### 1 Products affected

### 2 Type of change

Product Change Notification					PCN 4797		
owner	creation date	release date	released by	change order no	rev	page	0118.2295
import	2015-12-05	2016-04-08	huberth	2009672	A	1 of 2

Old product appearance	New product appearance

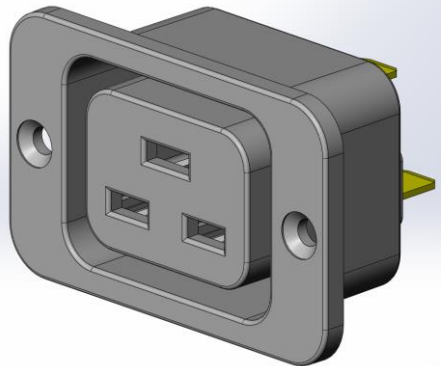
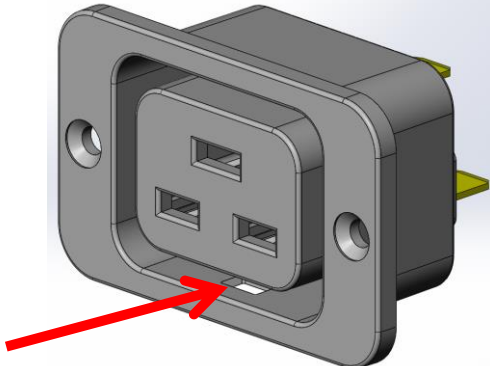
- Standard material changed from PA6 to PA66/6
- V-Lock feature integrated as standard (not an option anymore)

- Material change from PA6 to PA66/6 to pass the enhanced requirements of glow wire test according to IEC 60695-2-12 and -13
- V-Lock feature integrated as standard (not an option anymore)

Form	Yes	Socket has notch for V-Lock cord retaining
Fit	No	There are no dimensional changes
Function	Yes	V-Lock feature is standard (not an option anymore)
Production Site	No	There is no change of the production site
Product Label	Yes	There are new order codes
Customer Action	Yes	Consider the new order codes

Old order code	New order code
4797.xxxx.01 4797.xxxx.15	4797.xxxx 4797.xxxx
